Watts Bar Nuclear Plant, Unit 2
NRC Docket No. 50-391

Subject: Watts Bar Nuclear Plant (WBN) Unit 2 – Final Safety Analysis Report (FSAR) – Response to Requests for Additional Information

Response to RAIs Regarding Unit 2 FSAR

Figure 1 - Nuclear Power vs. Time

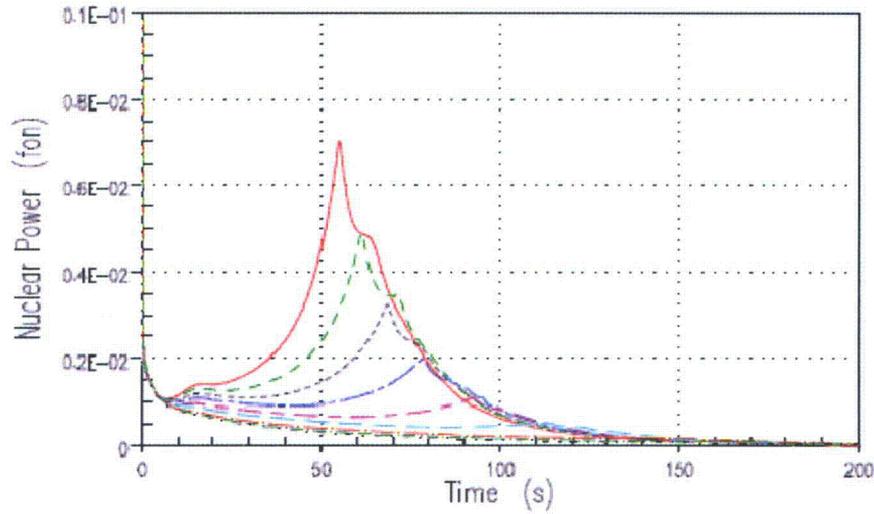
- a. *Support the claim that a minor secondary system pipe break would be less limiting than the major steam line rupture, since boric acid is supplied to the core by the accumulators during the major steam line rupture; but not necessarily during the minor secondary system pipe break.*

Transient plots that further demonstrate transient severity variability with break size are included on the following pages. Figure 1 shows Nuclear Power versus time for each of the cases run. The largest break shows the highest nuclear power with each successive case falling below the large break case. Figure 2 is core heat flux versus time. The trends seen are identical to the Nuclear Power curve. Figure 3 is RCS pressure versus time. As expected, the RCS pressure drops the most for the largest break. Figure 4 shows core reactivity versus time. The largest break case has the highest peak, and then drops the fastest due to the earlier accumulator and safety injection actuations, while the other cases follow as expected. Note that only the 4 largest breaks return to power (reactivity > 0.0). Figure 5 shows core boron concentration versus time. The largest break has the earliest and fastest increase in boron concentration due to the earlier accumulator and SI actuations and the lower RCS pressures (SI capacity is a function of pressure). The other cases follow as expected.
